# RE-ENVISIONING NORTHGATE MALL

Major Phased Development | DRB Recommendation - 03  
SDCI # 3032055-EG (MPD # 3031301)  
03 June, 2019 - Meeting Date  
Planner: Brandon Cummings

## BUILDING H1 - HOTEL

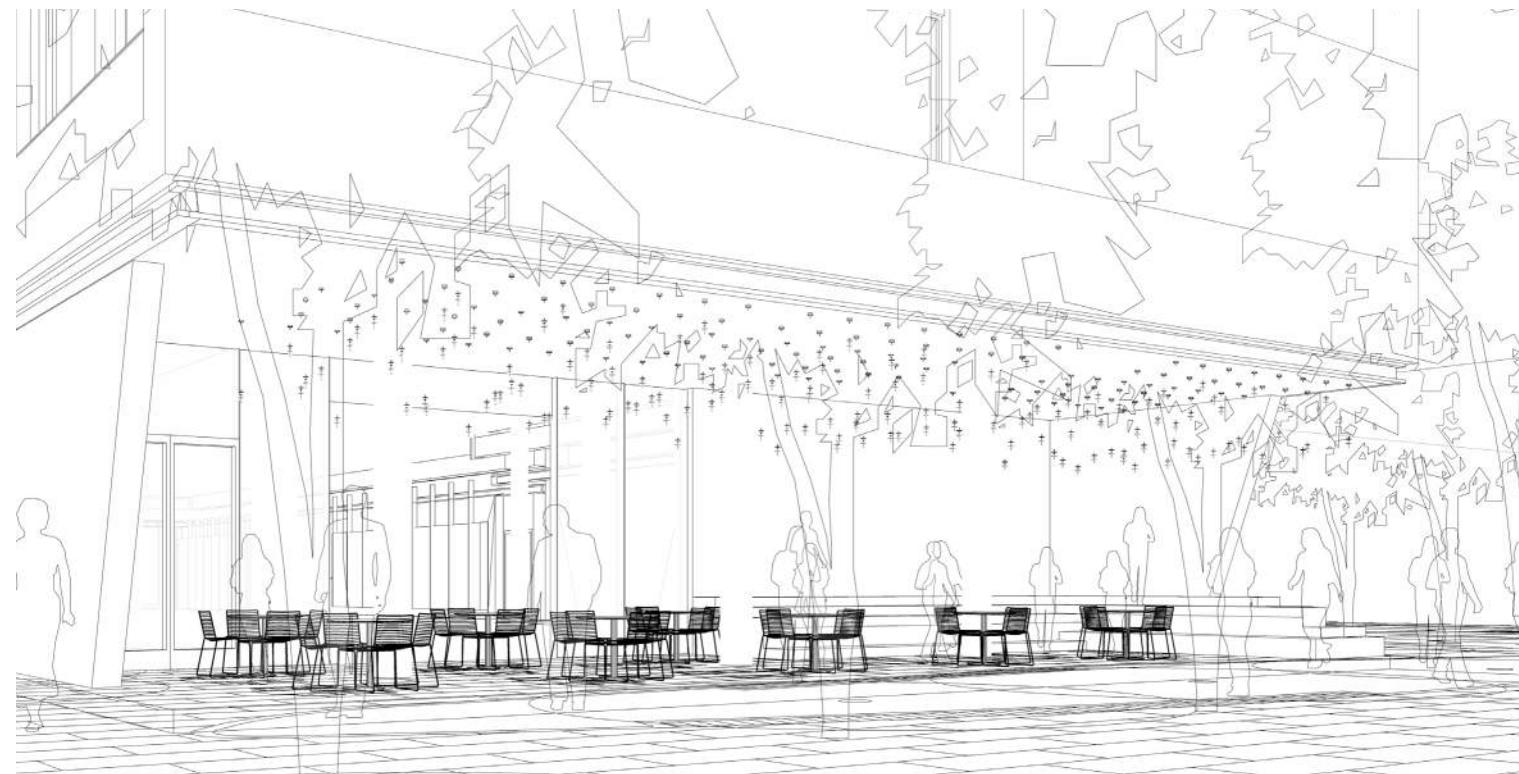
Board Comment: Design of the Retaining Wall: The Board was concerned with the design of the retaining wall on the west side of the parking lot just south of the H1 Hotel Building and recommended incorporating art or some other design elements along the wall to provide more visual interest for users on the adjacent multi-use trail.

*Response: The walls are currently being built by Sound Transit. Their final height and locations will be surveyed when construction fencing is removed and site becomes accessible.*

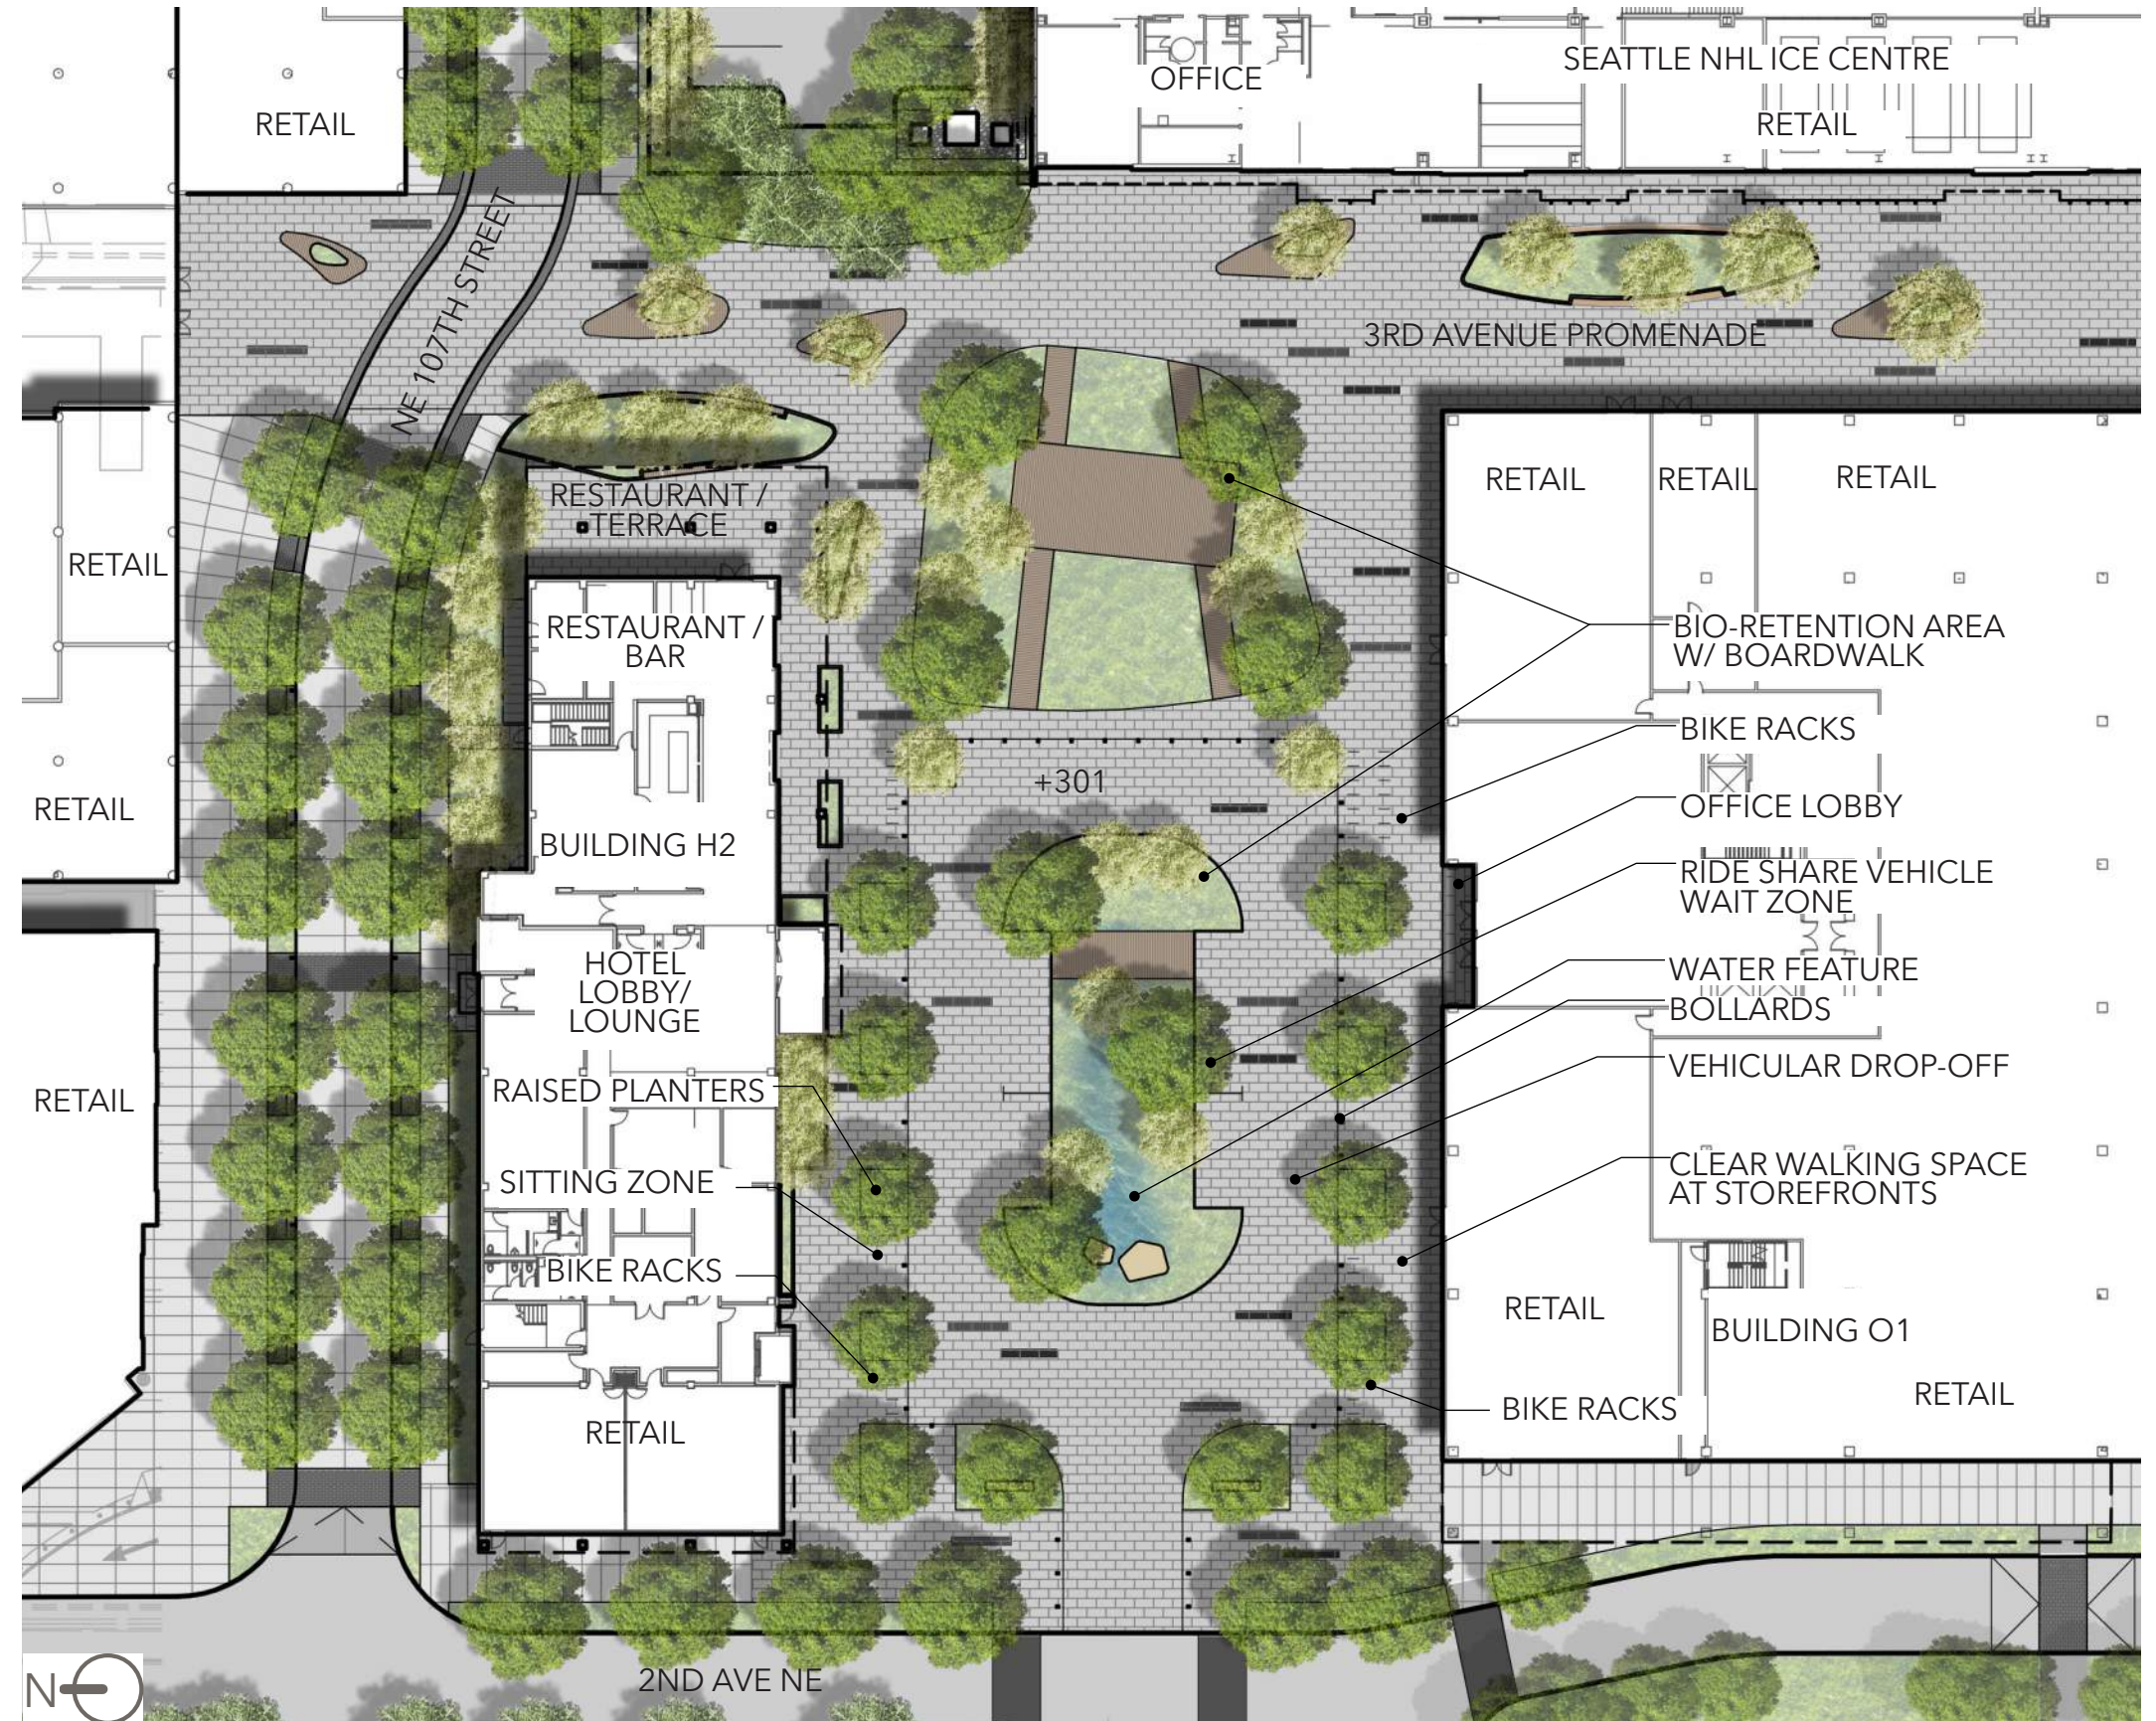
Board comment: Street Level Experience: The Board recommended exploring different approaches to integrating the ground level retail space with the hotel to create a ground floor experience that is more dynamic and promotes activity.

*Response: Hotel uses have been modified on the first floor, and the building now is engaging on all four sides. A covered terrace extends into the promenade, pulling restaurant experience and dining into the promenade, feeding off of its energy.*

Connect Water Feature and Bio-Retention with Dry Creek Bed

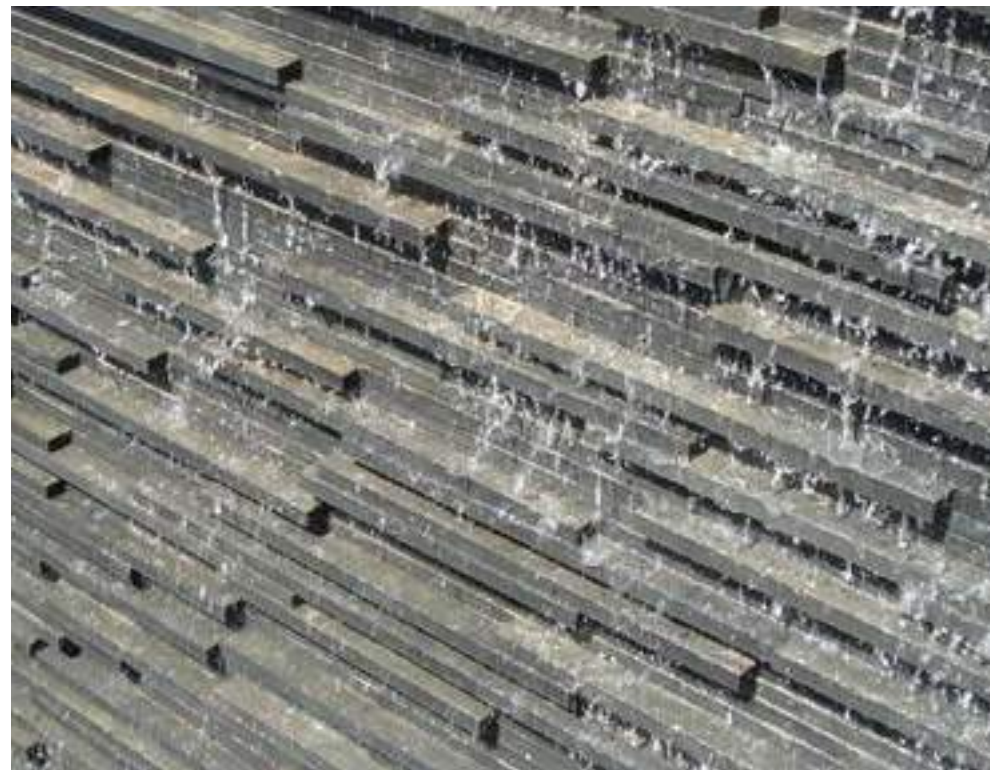
Board Comment: The Board indicated support for a physical or visual connection between the bio-retention area and water feature. The Board was concerned with the edge of the bio-retention area and how it meets the paving and requested more information on the design resolution of this edge condition.

*Response: The water feature was developed and refined. As an example, stacked stone formations could create the base of the water feature, water could flow into a small basin and its edges could blend into a dry creek bed in the bio-retention area. Edges around the bio-retention areas may have a curbed aspect, of stone, precast or cast-in-place concrete, 4" height minimum. For stormwater capture, curb will be interrupted.*

# LIGHTING DIAGRAM

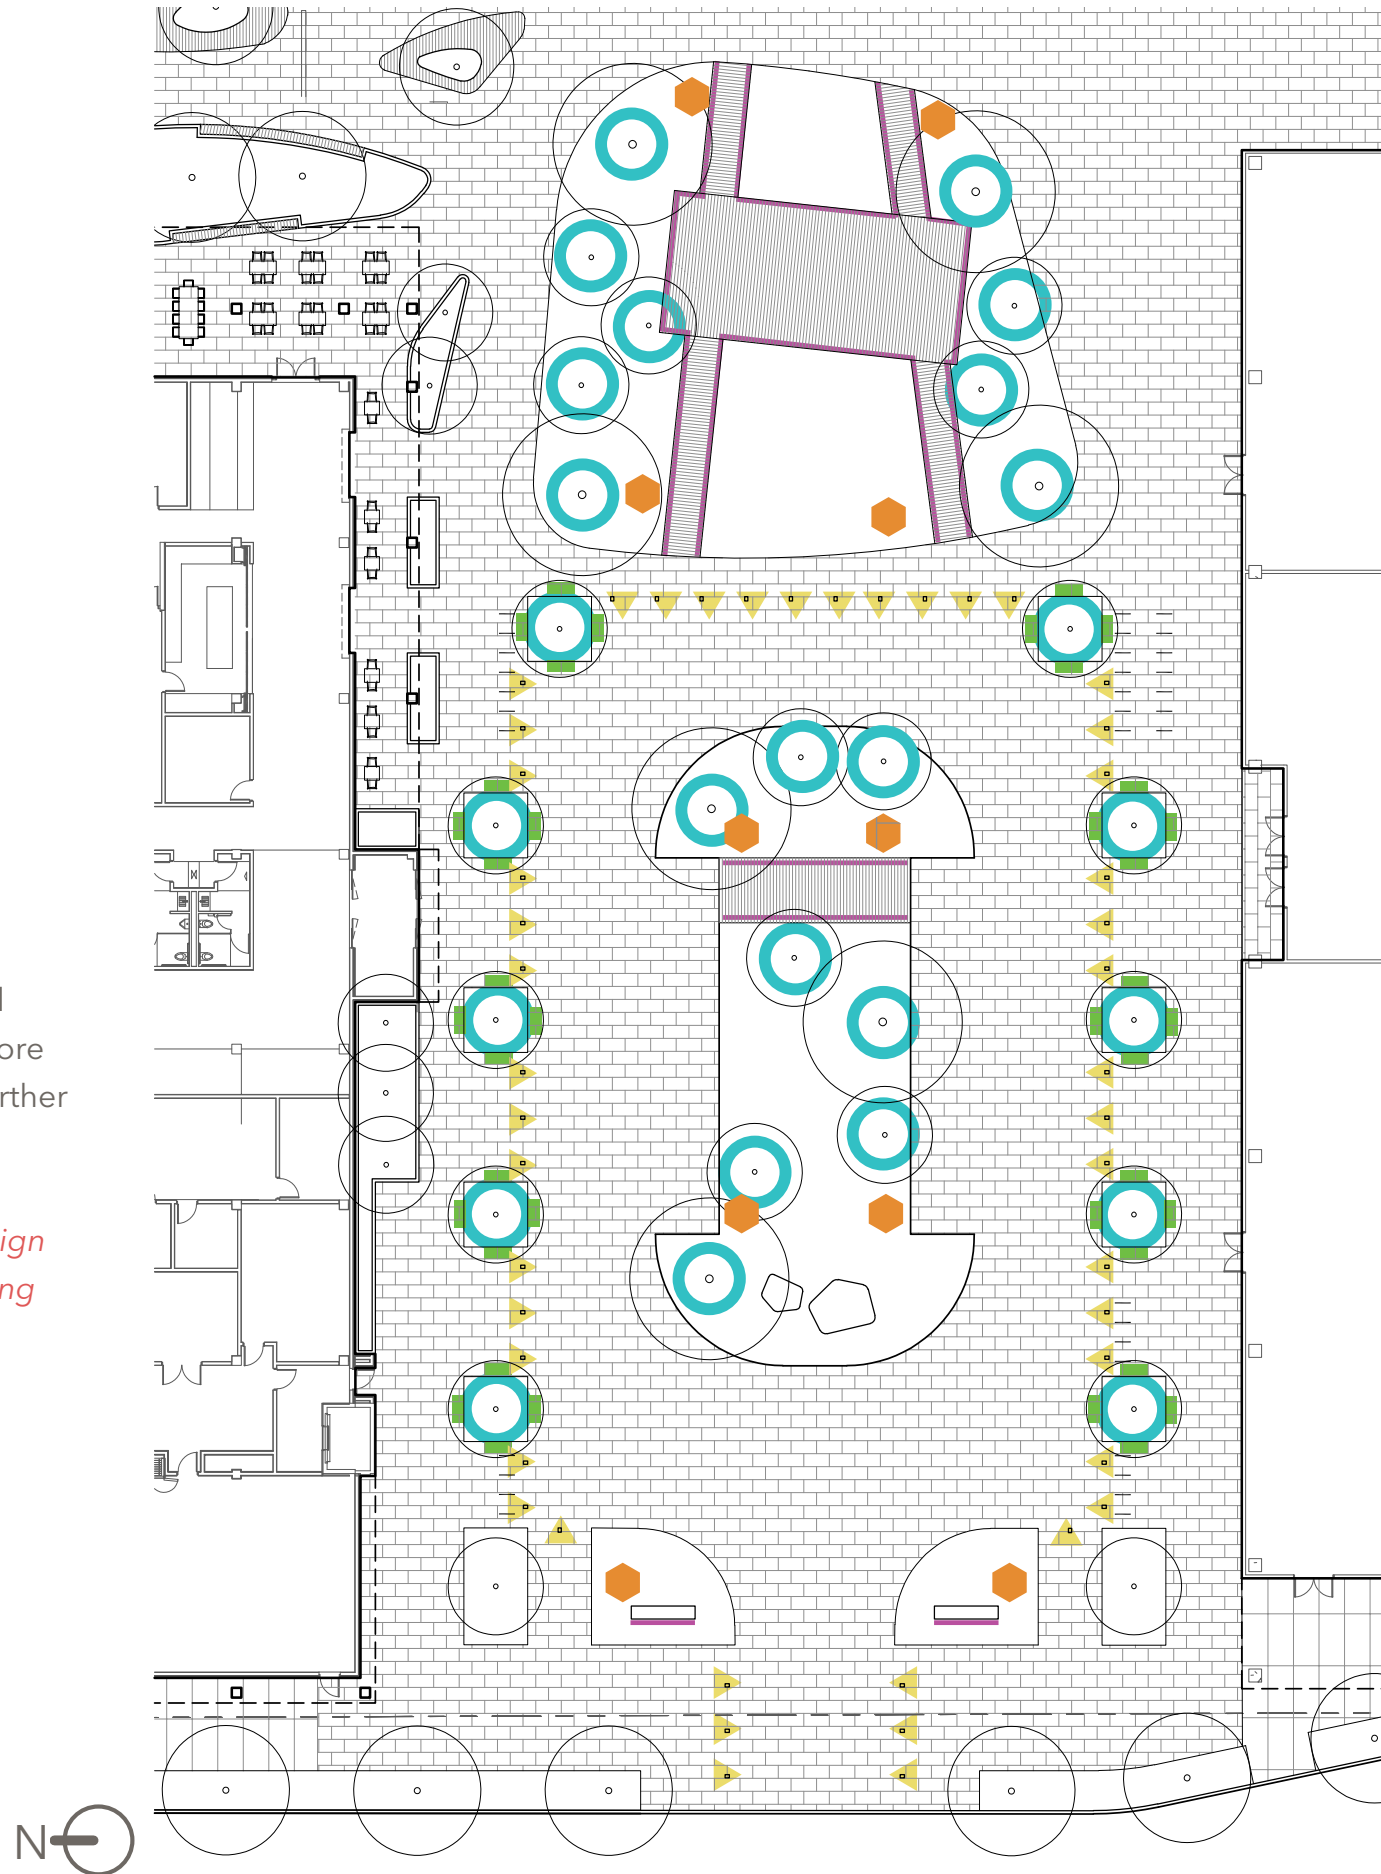
Board Comment: The Board considered the public comment provided but supported the singular feel of the plaza entry court that is reinforced through the paving strategy. The Board acknowledged lighting will be important to help improve safety and requested more information is provided at a subsequent meeting to further explain the strategy for this area.

*Response: Conceptual lighting plan provided. The design and fixture selection is consistent with the overall lighting design for Northgate.*

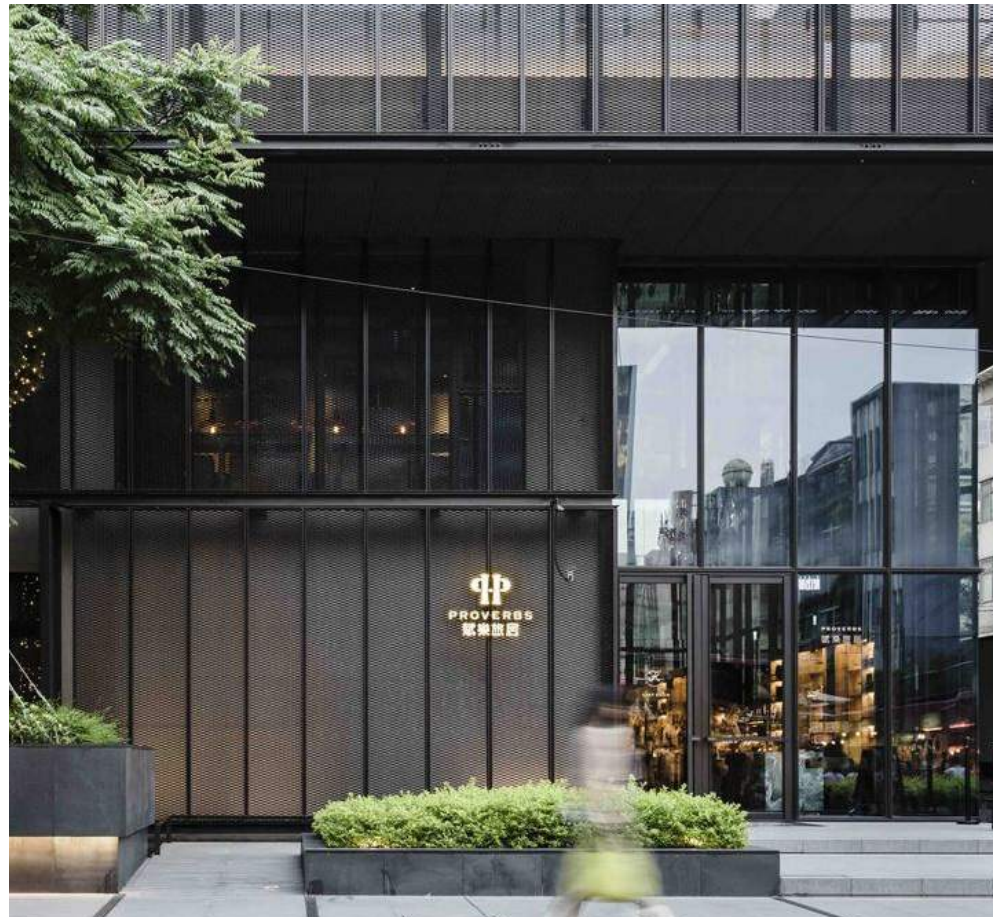
Comment: The Board was concerned with the design of the west façade which includes a colonnade along the ground level. There was support for the colonnade, highlighting how it can be used for overhead weather protection, but Board cautioned against potential blank wall conditions on the visible façade. (PL3-III. Stree Level Transparency)

*Response: The colonnade on the west façade of O1 is an integrated part to the design composition to provide weather protection and massing modulation at a macro scale. A minimum 60% transparency of the wall at grade. Distribution of the transparency will be dictated by the programming and functional design process of the ground level uses. The solid walls will use design strategies of texture, human scaling elements, and proportions through the materiality and installation of green vertical walls.*
